UNITED STATES PATENT AND TRADEMARK OFFICE

APPLICATION NO.	FILING DATE	FIRST NAMED INVENTOR	ATTORNEY DOCKET NO.	CONFIRMATION NO.
10/628,045	07/25/2003	Andre Linnenbrugger	3191/11394-US1	4032
7278	7590	04/03/2006	EXAMINER	
DARBY & DARBY P.C.			CHARLES, MARCUS	
P. O. BOX 5257			ART UNIT	
NEW YORK, NY 10150-5257			PAPER NUMBER

Office Action Summary	Application No. 10/628,045	Applicant(s) LINNENBRUGGER ET AL.	
	Examiner Marcus Charles	Art Unit 3682

DETAILED ACTION

DE 197 43 676 A1

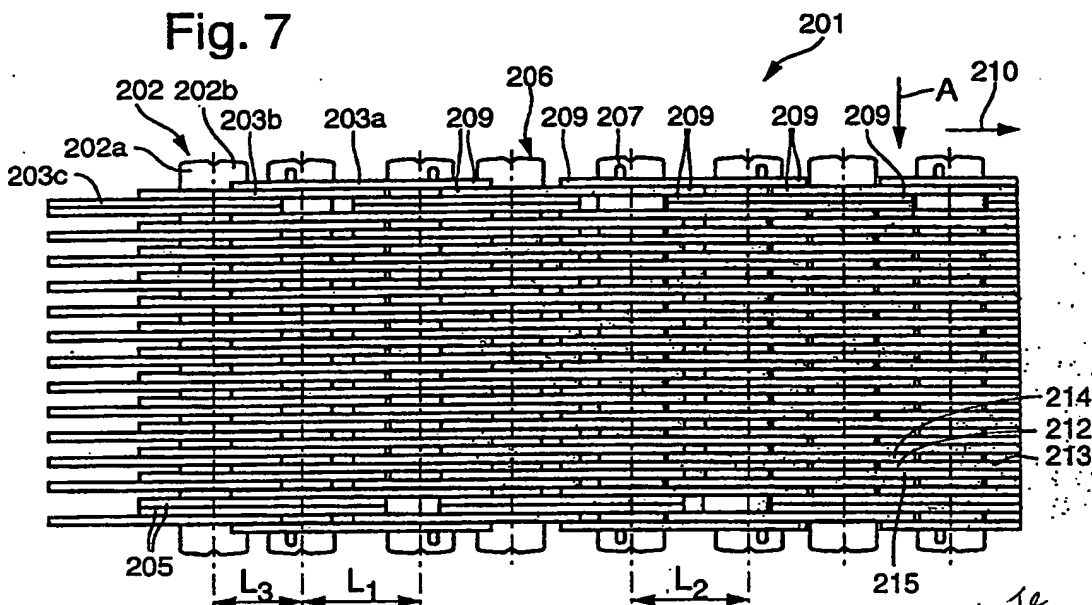
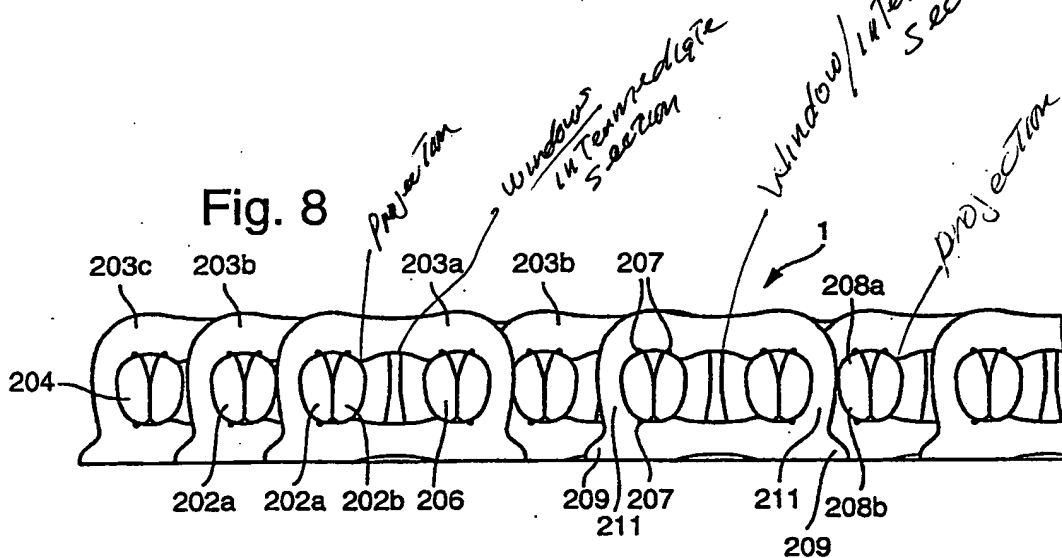
5. Claim 2-4 and 14-16 are rejected under 35 U.S.C. 103(a) as being unpatentable over DE (19743676). DE (19743676) discloses the claimed invention including the coupling (206) being rockable about axes normal to the respective link plates (203) and the couplings (206) having round external surfaces contacting the rounded internal surface of the link plates. DE (19743676) also discloses the radii of curvature of the internal surfaces and external surfaces is variable (see figs 3a, 3b, 8, 9, 11) but does not disclose the ratio of round surface radii of curvature of the external surface of coupling and that of the rounded internal surface of the links is less than ten. However, it appears that the outer radius of the coupling (206) and the inner radius of the links are substantially the same, which means that the ratio is substantially one or more but is not more than ten since the difference of the radii is small. In addition, would have been

In claim 15, note the projections and the intermediate sections in the attached drawing and it is apparent that the windows and projection are shaped to prevent the displacement of the coupling elements.

In claim 16, note the projections extend into the respective elongated windows (see attached drawing).

Fig. 1

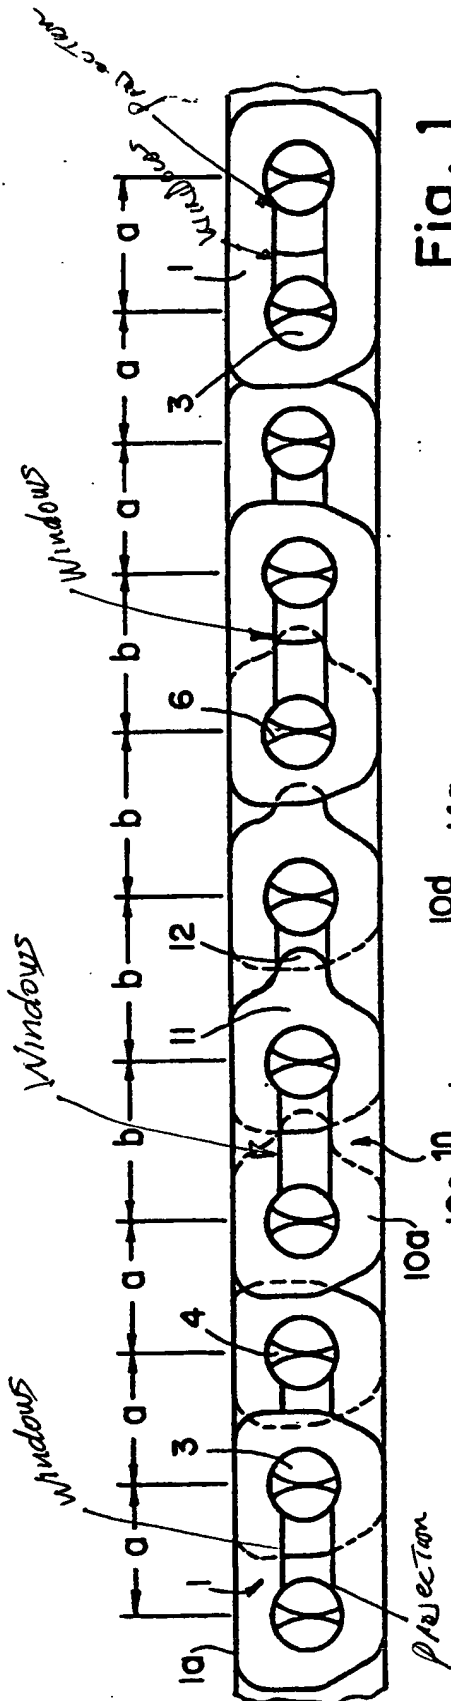
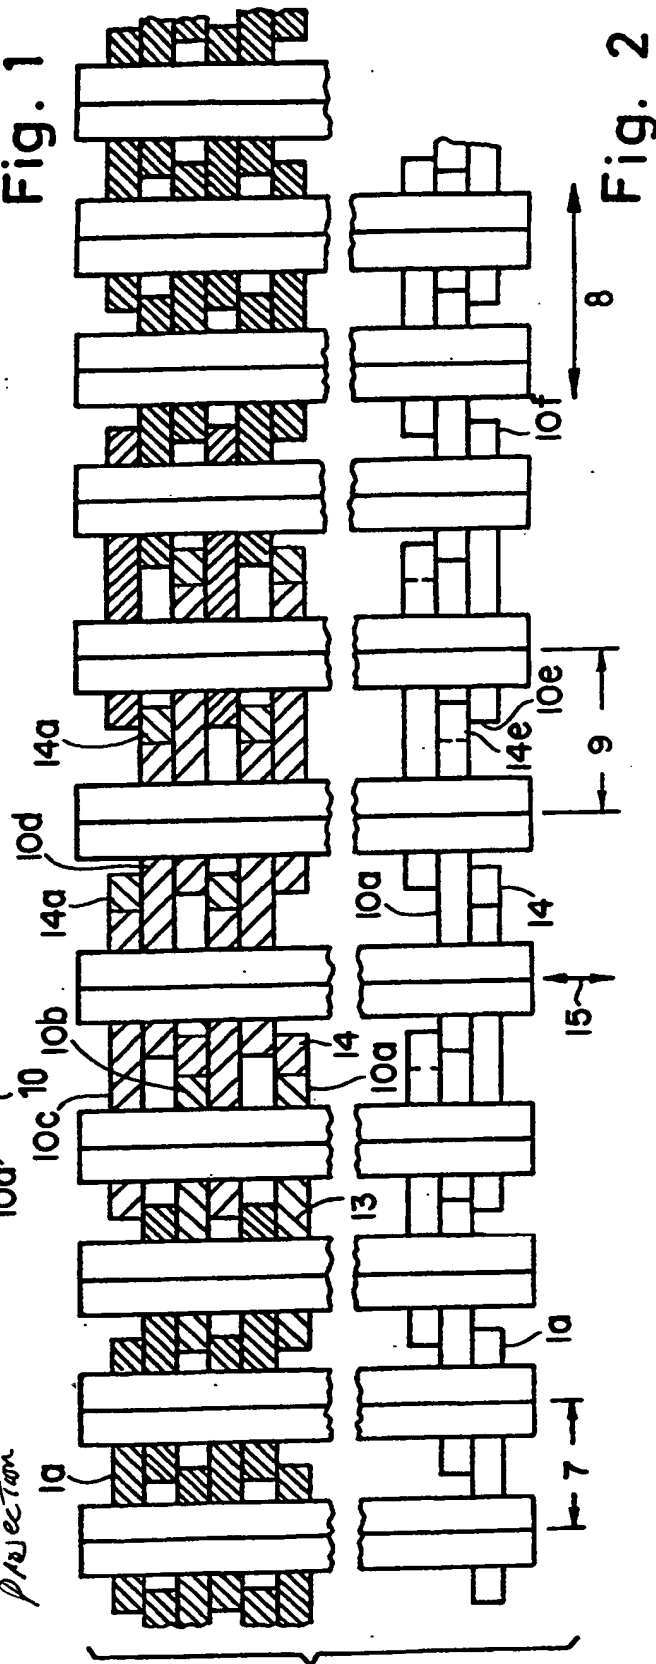
4. Claims 2-4 and 15-16 are rejected under 35 U.S.C. 103(a) as being unpatentable over Wolf. In claims 2-4, 15 and 16, Wolf discloses the claimed invention including the coupling (6) being rockable about axes normal to the respective link plates (1) and the couplings (3) having round external surfaces contacting the rounded internal surfaces of the link plates. Wolf does not disclose the ratio of round surface radii of curvature of the external surface of coupling and that of the rounded internal surface of the links is less than ten. However, it appears that the outer radius of the pin/coupling (3) and the inner

In claim 15, Wolf discloses the claimed invention above. It is apparent that the Windows are shaped to prevent displacement of the coupling units (3) (see attached drawing).

In claim 16, Wolf discloses the projection at the end of the windows (see attached drawing).
